Re: St. Lucie Plant Unit 1
Docket No. 50-335
Renewed Facility Operating License No. DPR-67

Response to NRC Reactor Systems Branch Request for Additional Information
Regarding Extended Power Uprate License Amendment Request

St. Lucie Unit 1 EPU – Information to Support
NRC Review of CVCS Malfunction

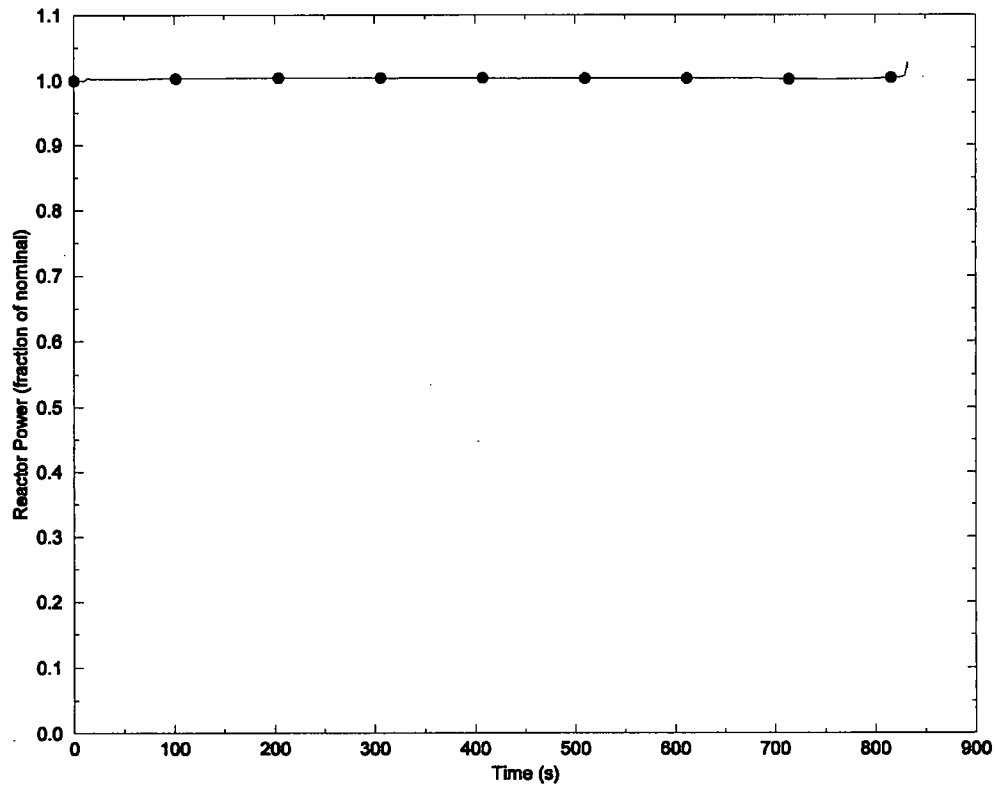
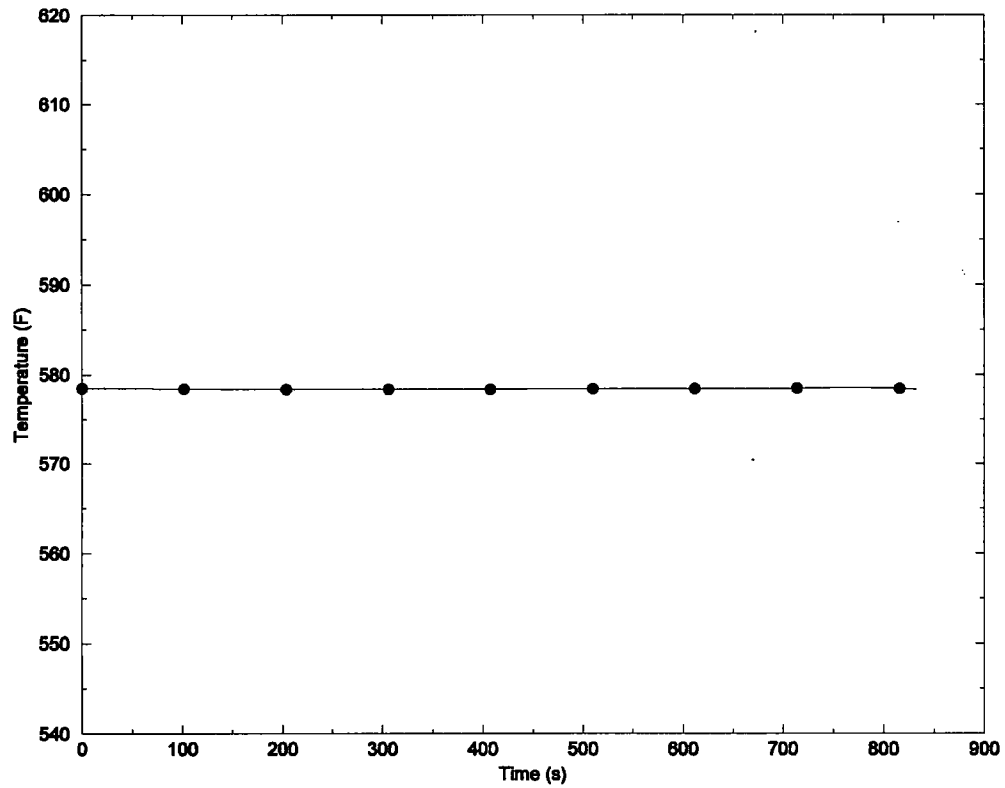
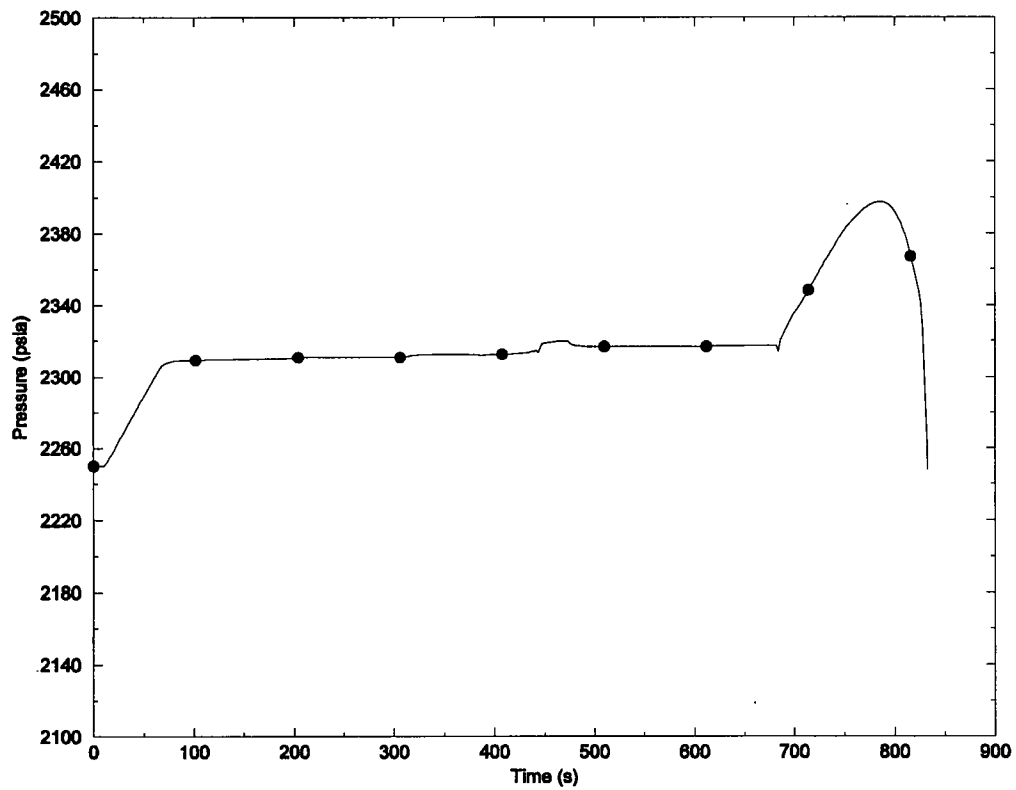
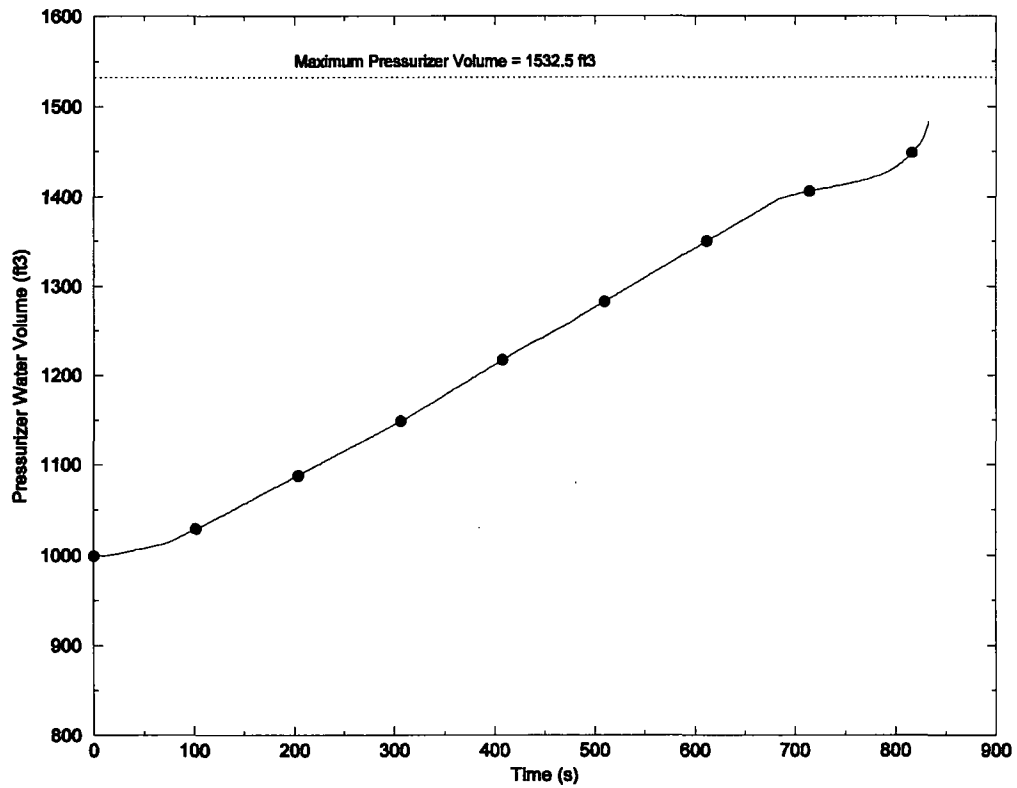
SRXB-36: [2.8.5.5.a]: The St. Lucie FSAR §15.1.1, "Classification of Accidents", states that the Chapter 15 accident analyses are based on RG 1.70 and NUREG-0800. Both documents include the Chemical and Volume Control System Malfunction. The latter reference contains guidelines for review of analyses of the Chemical and Volume Control System Malfunction that Increases Reactor Coolant Inventory in all operating modes. Please supply an analysis of the Chemical and Volume Control System Malfunction that Increases Reactor Coolant Inventory.

SRXB-37: [2.8.5.5.b]: The application notes that high-head safety injection pumps are not capable of injecting water into the reactor coolant system at normal operating pressure. However, the application also proposes a change in the Technical Specifications (TS 3/4.5.2, EMERGENCY CORE COOLING SYSTEMS (ECCS) – OPERATING) that would add LCO 3.5.2.d, which accounts for the incorporation of the charging pumps into the ECCS. Since the charging pumps are capable of injecting water into the reactor coolant system at normal operating pressure, the Inadvertent Operation of the ECCS is a credible event and ought to be analyzed. Provide an analysis of the Inadvertent Operation of the ECCS consistent with the SRP guidelines and Regulatory Issue Summary (RIS) 2005-029.

A single limiting case was analyzed for the CVCS Malfunction event at hot full power (HFP) conditions. The sequence of events is shown in Table 2. The system response is presented in Figure 1 to Figure 4. The analysis showed that the operators will have more than 13 minutes from the event initiation to terminate the event. The analysis also showed that the operators have 651.125 seconds (more than 10 minutes) from the time of receipt of the pressurizer high level alarm to terminate the event before the pressurizer reaches a water-solid condition.
